CITY OF YPSILANTI
Historic District Commission
Regular Meeting Agenda

Tuesday, October 11, 2016
7:00 p.m.

HDC Work Permit Staff Review

Property address: 410 N. Huron St.

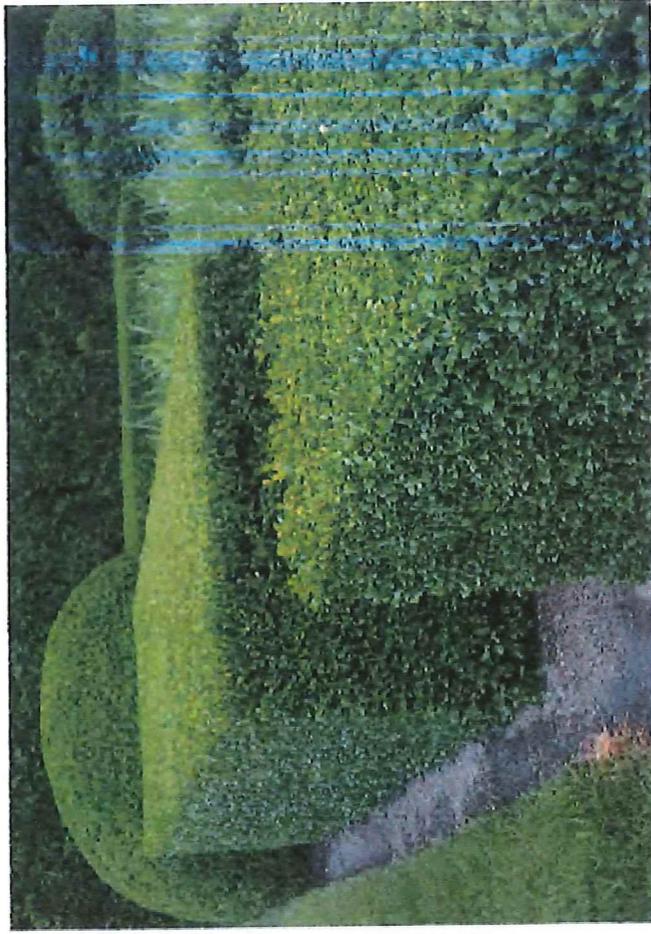
1. This application was tabled from the September 27, 2016 meeting due to the HDC requesting additional light fixture examples be brought to the next meeting.
2. Staff advised applicant about proposed light fixture imitating an earlier style and suggested that other options be brought to the meeting as alternatives.
3. HDC to verify the height of the boxwoods.
4. Before proceeding with work, the applicant must seek the appropriate building department permits.

Work to include the replacement of the track lighting on the front porch with new light fixtures. Repair and stain the existing front door in either the Yankee Barn or Riverwood color. Replace the existing Yews in the front lawn with the Green Mountain Boxwood Hedge Row.
